## Assessment of Adanac Cycle Route - East of Gore

November 1, 2013

### *Adanac Street and Clark Drive*

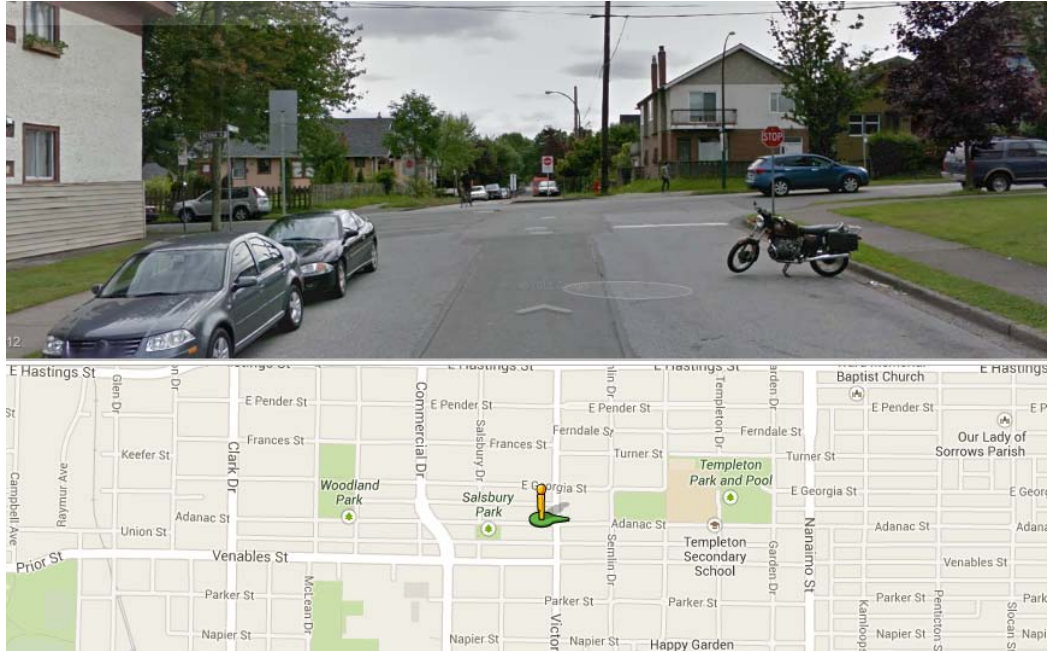
HUB is encouraged by the new island eastbound on Adanac Street and Clark Drive. However, the push-button light activation remains at the right curb. Requiring cyclists to move to the right curb to press a pedestrian button defeats the purpose of the island. It is particularly difficult for cyclists who need to turn left as they must cross traffic continuing straight on Adanac Street.

HUB recommends that the City install Bicycle-activated loop detectors at the island and on the west side of the intersection. Such detectors allow the presence of a bicycle to trigger a change in the traffic signal. This allows the cyclist to stay within the lane of travel and avoid manoeuvring to the side of the road to trigger a push button.

### *Adanac Street and Renfrew Street*

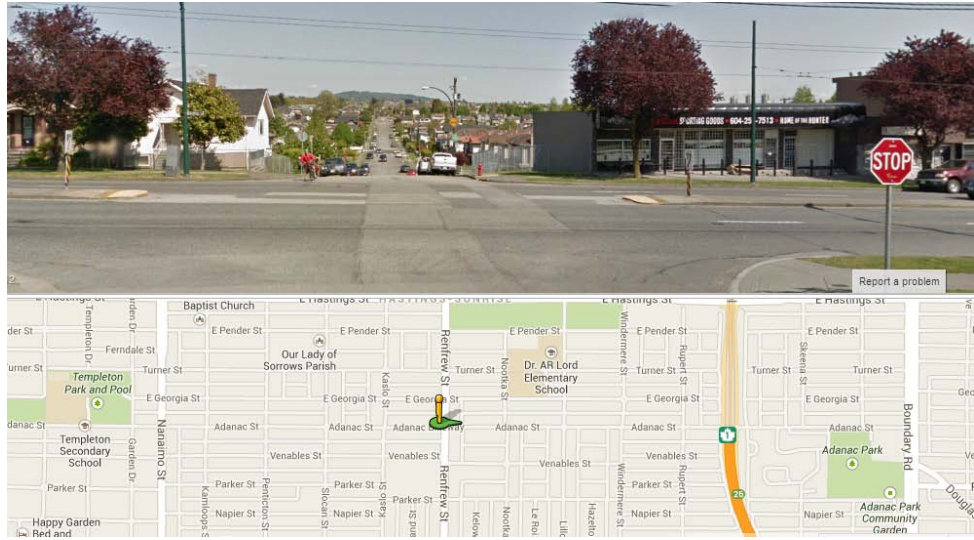
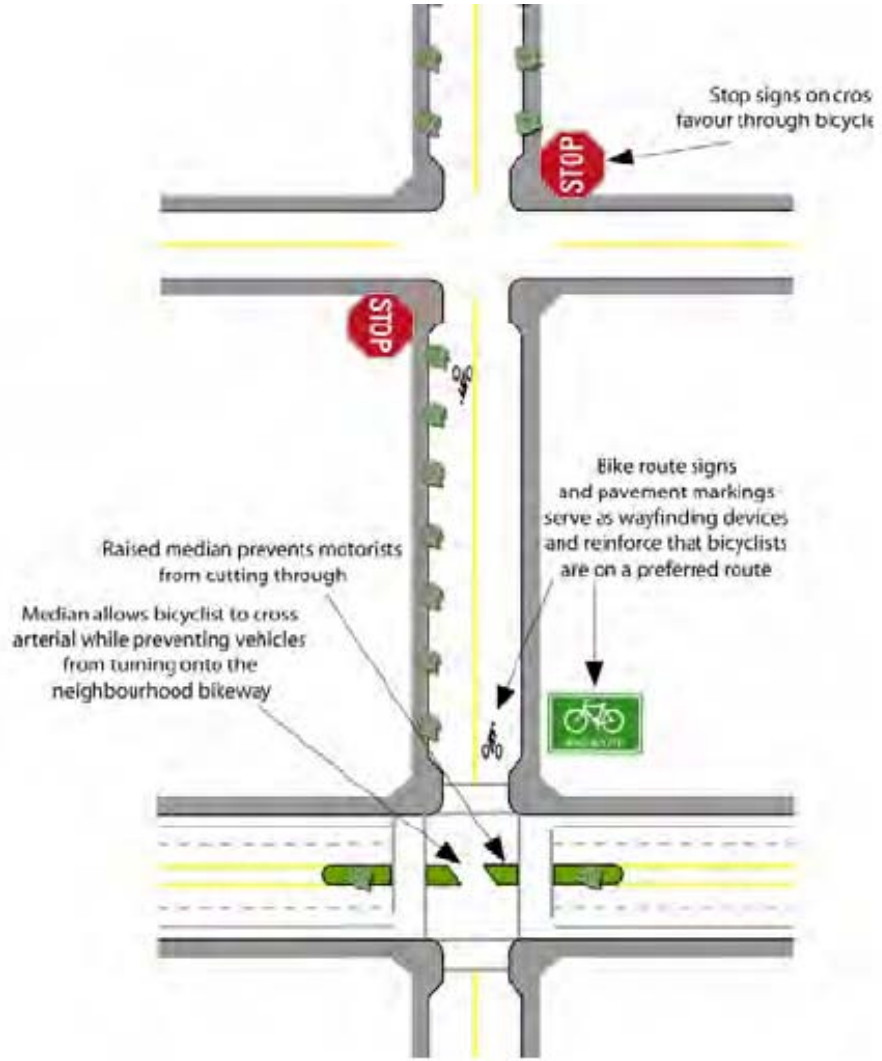
The intersection at Adanac Street and Renfrew Street is particularly dangerous for cyclists. It is not an AAA intersection. Cyclists must cross four lanes of high-speed traffic without the benefit of a stop sign for north-south traffic. In addition, the constant, high volume of traffic on Renfrew Street requires significant delay in the cyclist's trip.

HUB recommends the installation of a stoplight and a bicycle activated loop detector. In the alternative, the refuge island should be more secure and wide enough to accommodate cyclists. A more effective refuge can be found at 8<sup>th</sup> Avenue and MacDonald Street.

### *Windermere & Adanac:*

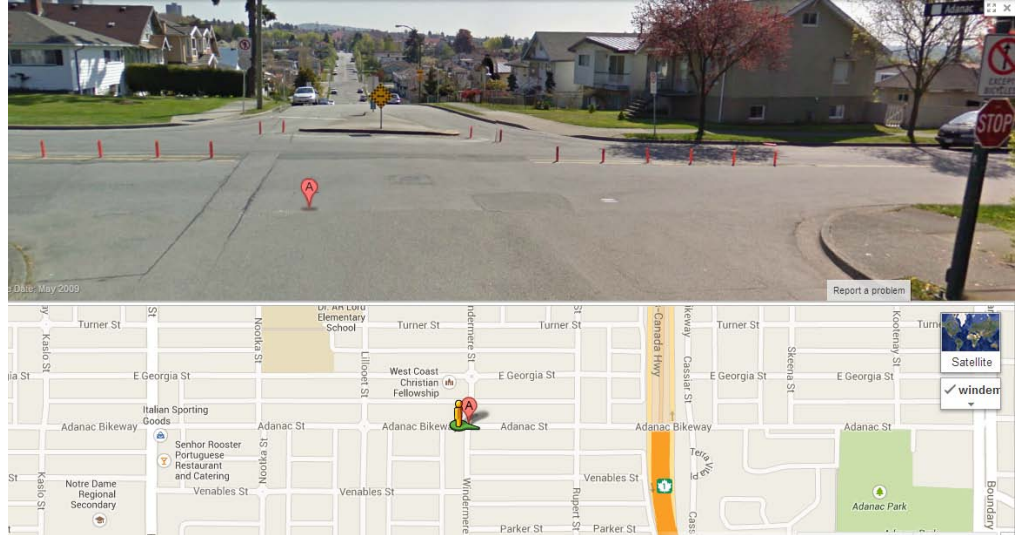
The flexible bollards at this intersection are confusing and do not conform to traffic markings used elsewhere in the City. We recommend the use of green paint and bike stencils to clearly identify cyclist zones.

### *Adanac Street & Cassiar Overpass to Boundary Street*

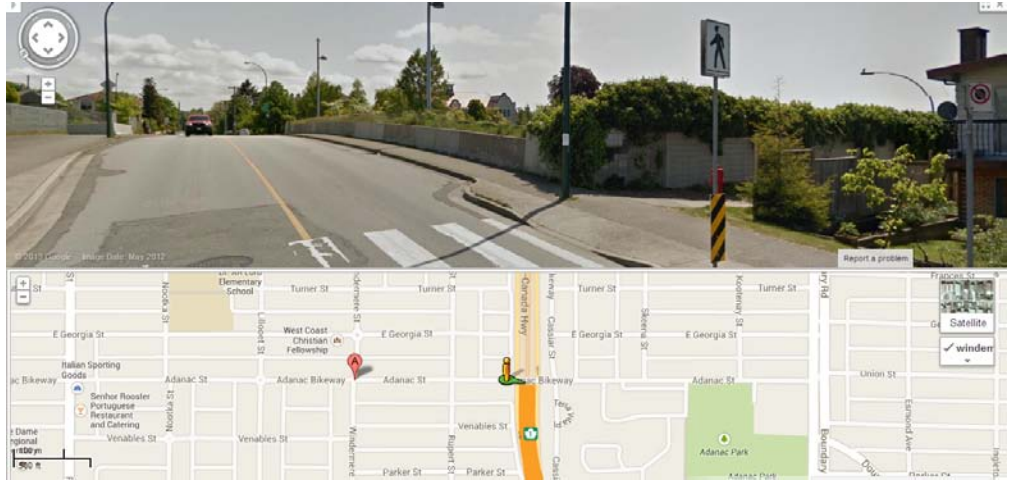
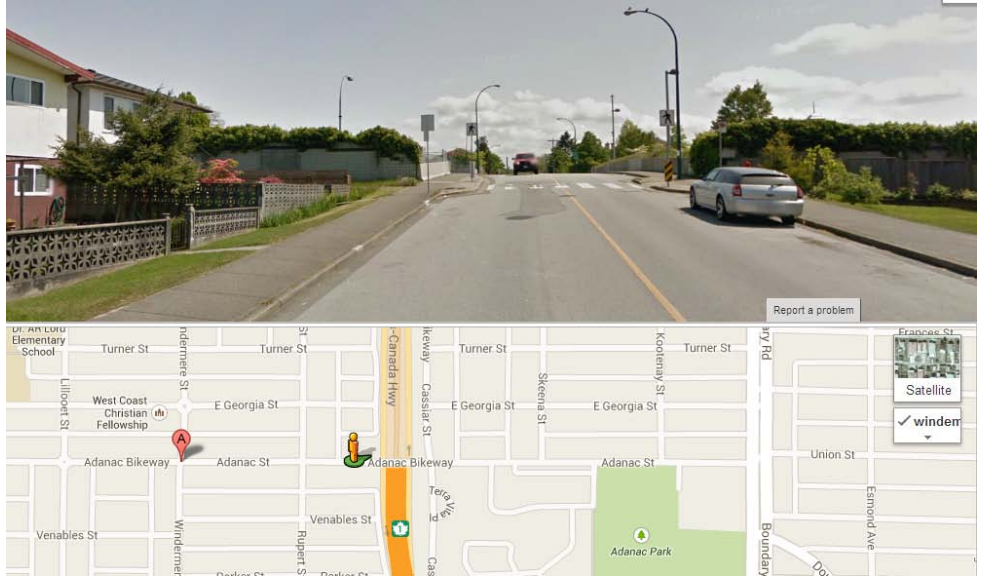
The Cassiar overpass is a dangerous area for cyclists and motorists. There is no marked bicycle lane or signs indicating to cars to share the road. Cyclists are going slower uphill eastbound and cars pass into oncoming traffic that is travelling over the hill to get around them. The parking and pedestrian bulges narrow the street forcing those cycling to "take the lane". Cyclists report that traffic speeds through the area to connect between Rupert and Boundary exceed 50 km/h.

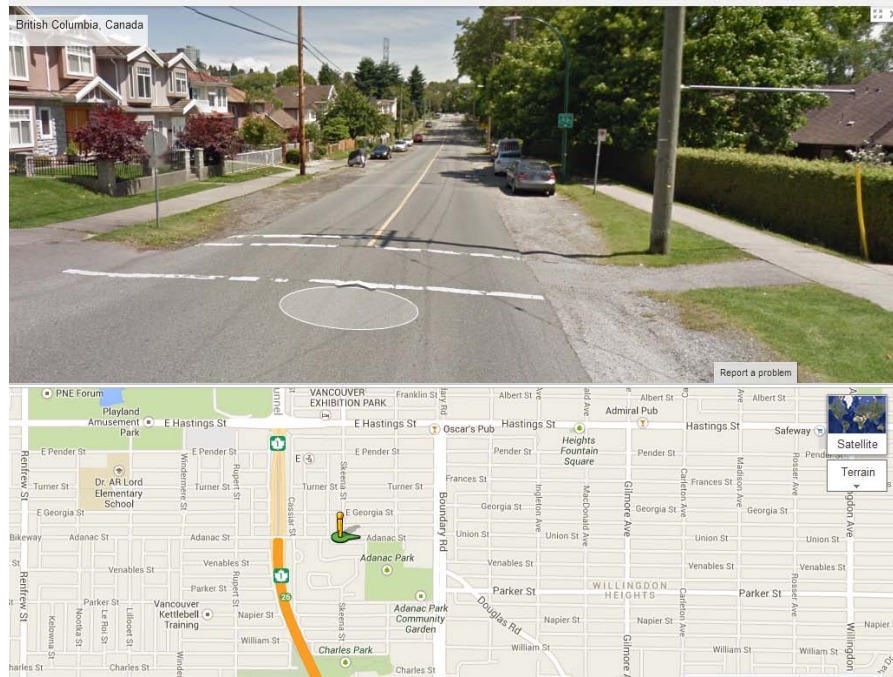
Between the overpass and Boundary Road, the sides of Adanac Street become gravel. We recommend that the City pave the sides of Adanac Street to eliminate sliding, ruts and potholes. This is a busy street unlike further west which is traffic calmed. Paving the sides would increase space for cyclists who must still distance themselves a metre from the opening doors of parked cars.
